Subject: 10CFR21 Reporting of Defects and Non-Compliance -
Engine Systems, Inc. Report No. 10CFR21-0133, Rev. 0

Swing Check Valve, P/N ESI50359

Report No. 10CFR21-0133

COMPONENT: Swing Check Valve, P/N ESI50359

Figures 1 & 2: View of Swing Check Valve P/N ESI50359

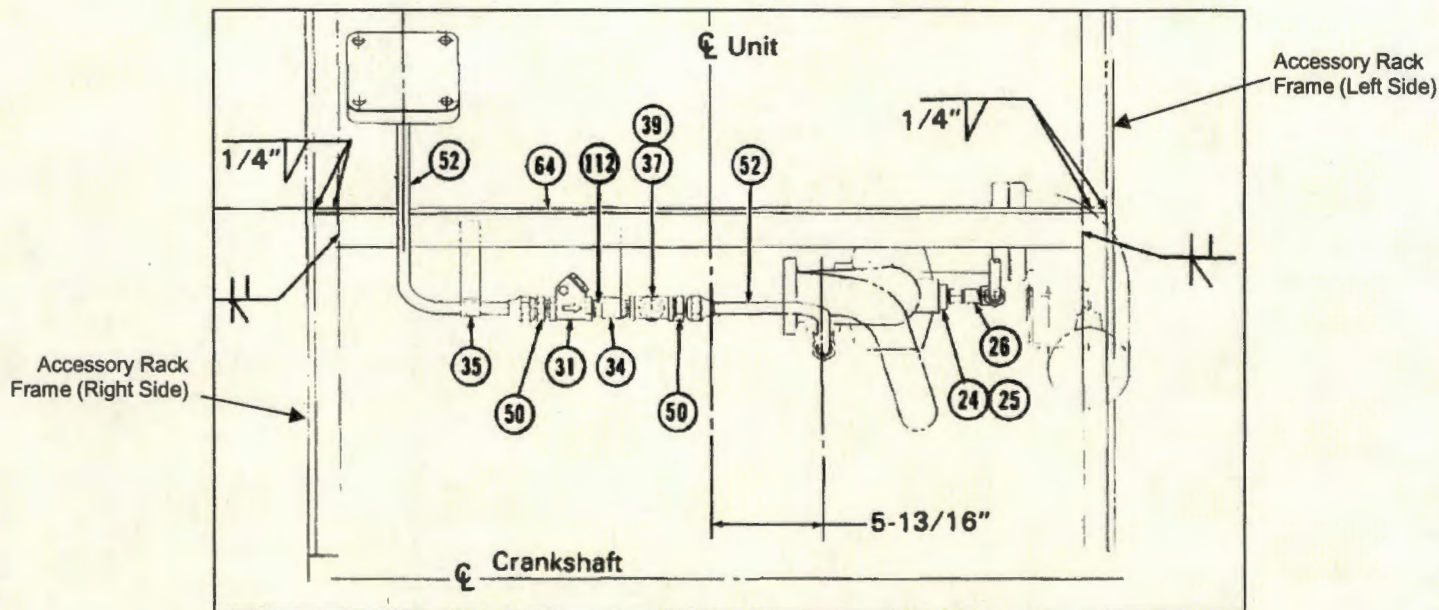
The hinge pin retainer plug used on check valve P/N ESI50359 may exhibit low breakaway torque and thus minimal resistance to loosening when subjected to engine operating vibrations. Consequently, if the plug were to completely dislodge, followed by the associated hinge pin, the pressure boundary of the lube oil system would be compromised and oil would discharge through the 3/16" diameter opening. ESI was notified by a nuclear customer of such an occurrence on a check valve that had been recently installed. Following notification, ESI inspected remaining check valves in inventory and confirmed an issue where the plug exhibited low breakaway torque that could potentially lead to unintended loosening.

ESI recommends a rework of the check valve. Remove the hinge pin retainer plug and ensure plug threads and PTFE washer are free from damage or distortion. Apply Loctite 243 sparingly to clean plug threads then re-install the plug and PTFE washer, using caution to minimize seepage of thread locker. Using a 10mm socket, torque the plug to 5 (± 0.5) in-lbs and allow the Loctite to cure.
